**RE: Las Lomas Plaza – Unit 2
Grading and Drainage Plan
Engineer's Stamp Date: 03/28/18
Hydrology File: H10D031**

LAS LOMITAS PLAZA - PHASE II

GRADING & DRAINAGE PLAN

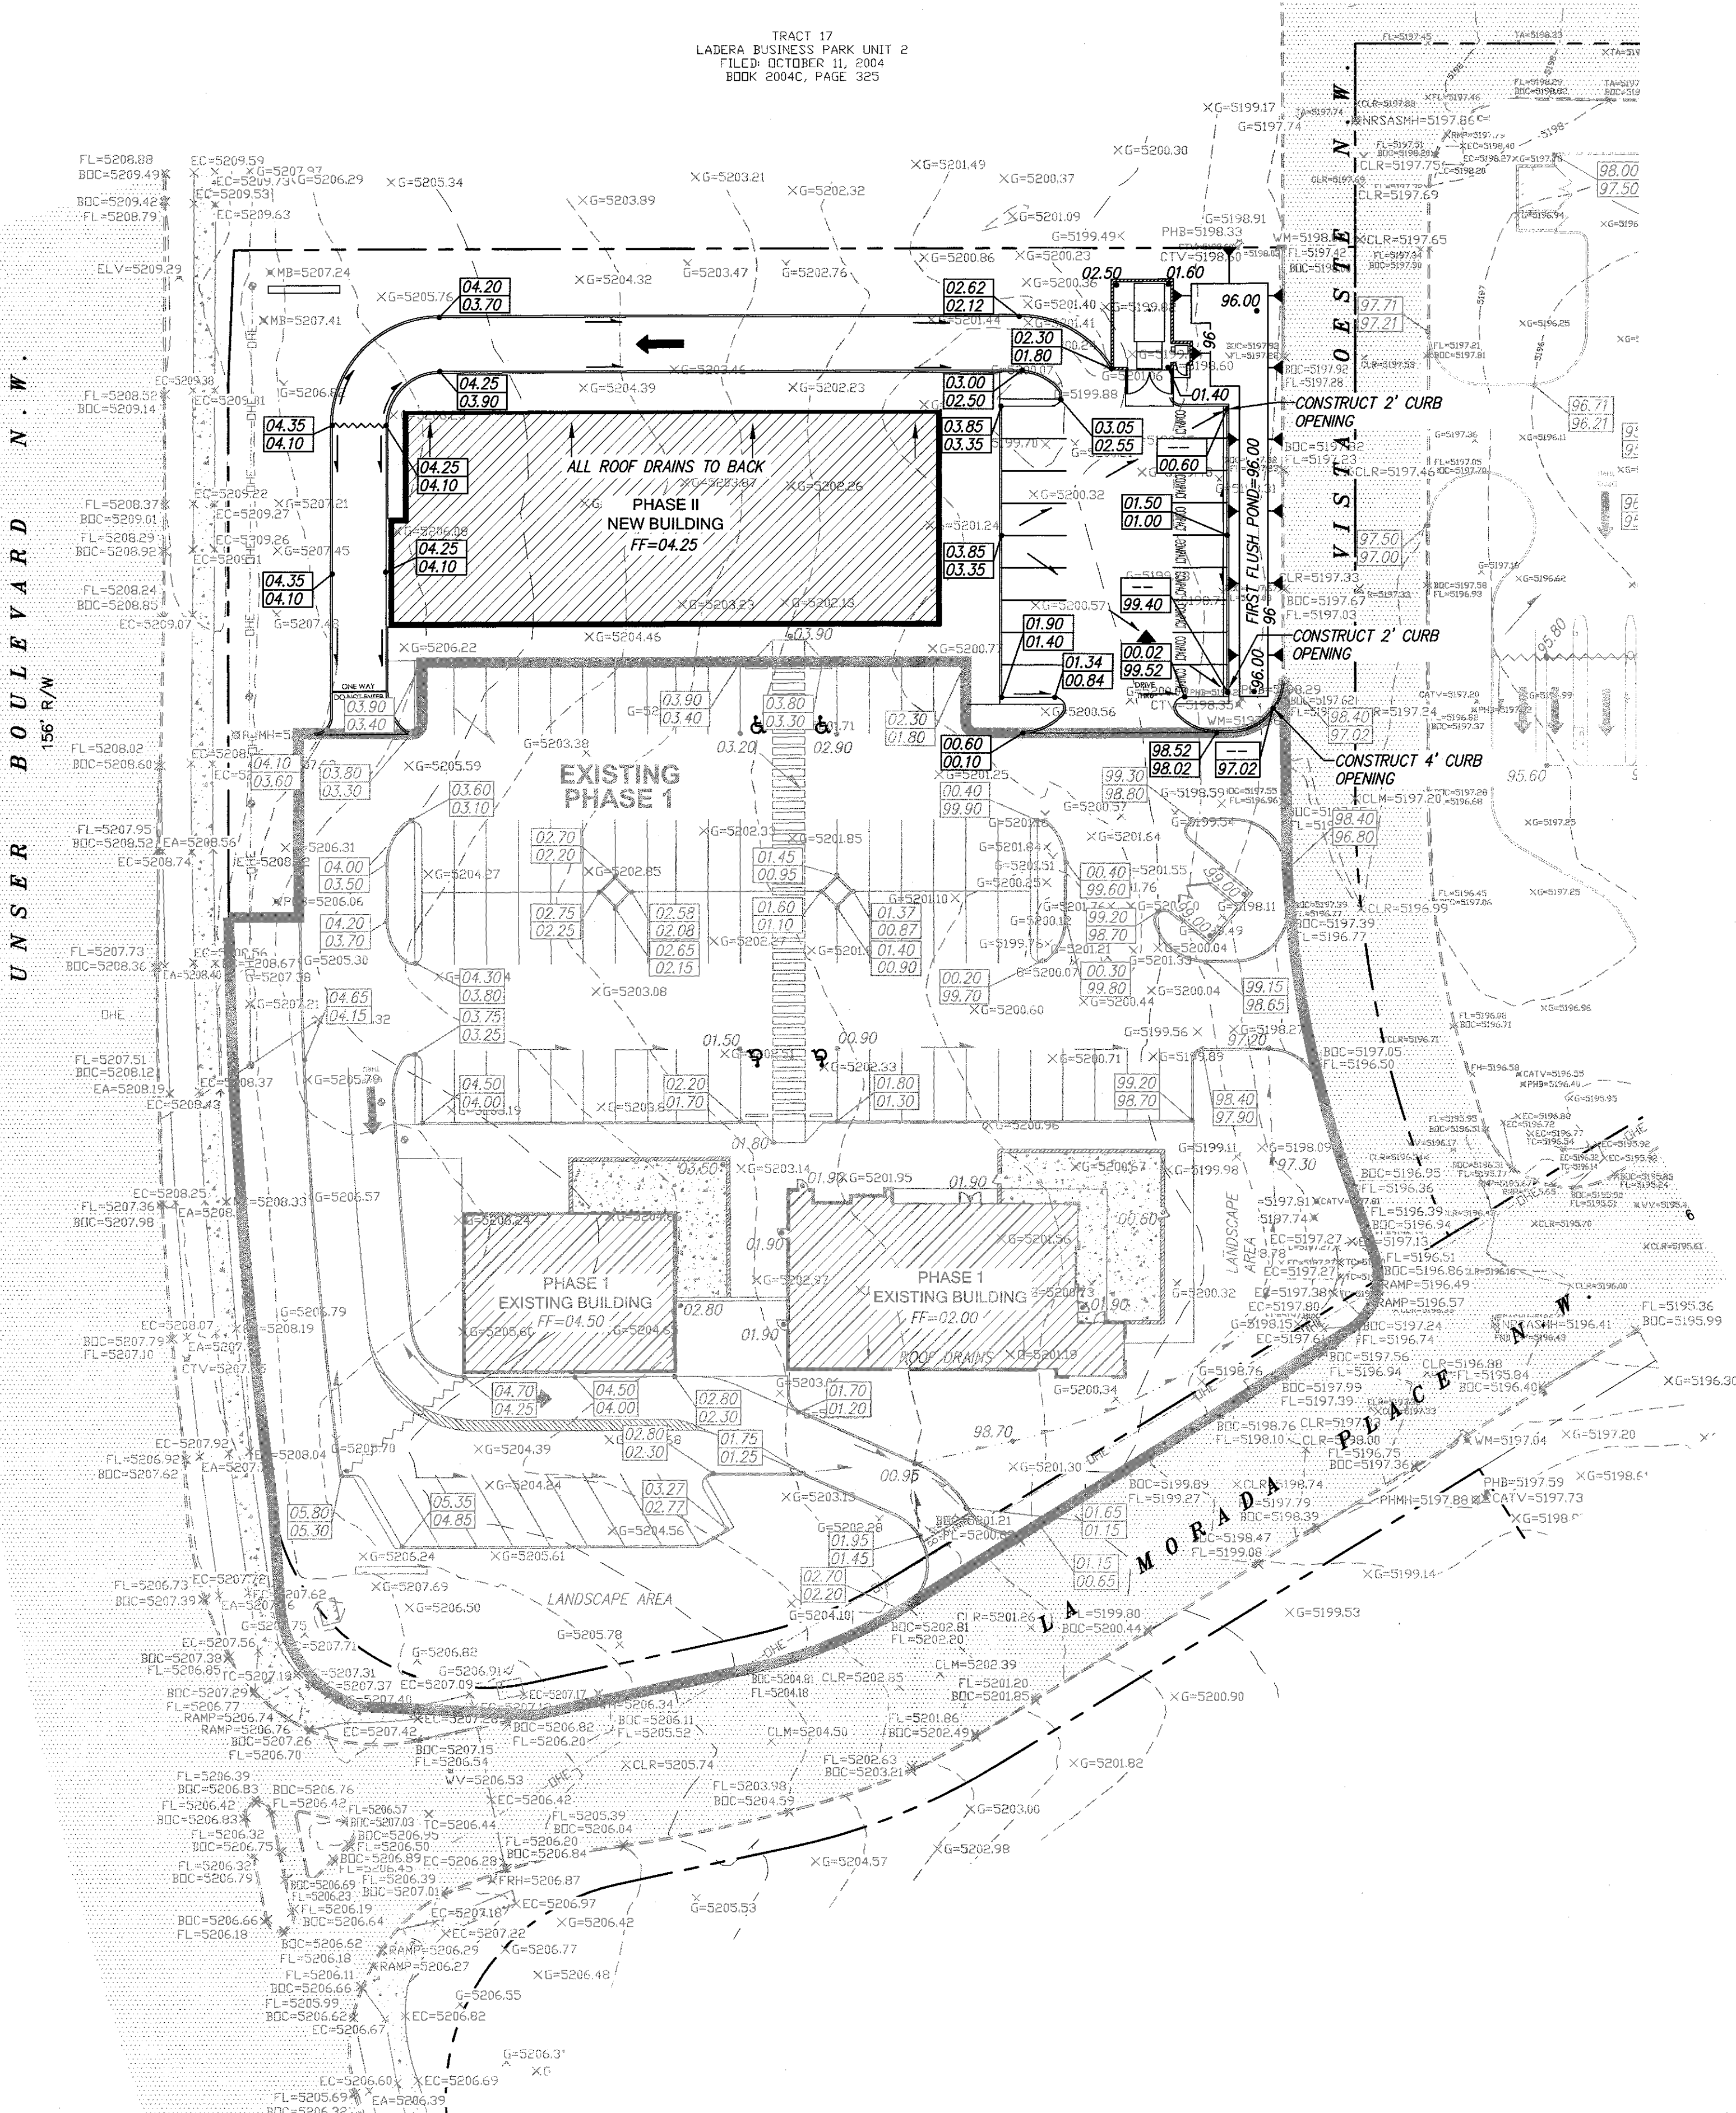
Based upon the information provided in your submittal received 03/29/2018, the Grading Plan is approved for Building Permit.

Please provide a Private Facility Drainage Covenant per Chapter 17 of the DPM for first flush pond prior to Certificate of Occupancy. Please submit this on the 4th floor of Plaza de Sol. A \$25 fee will be required.
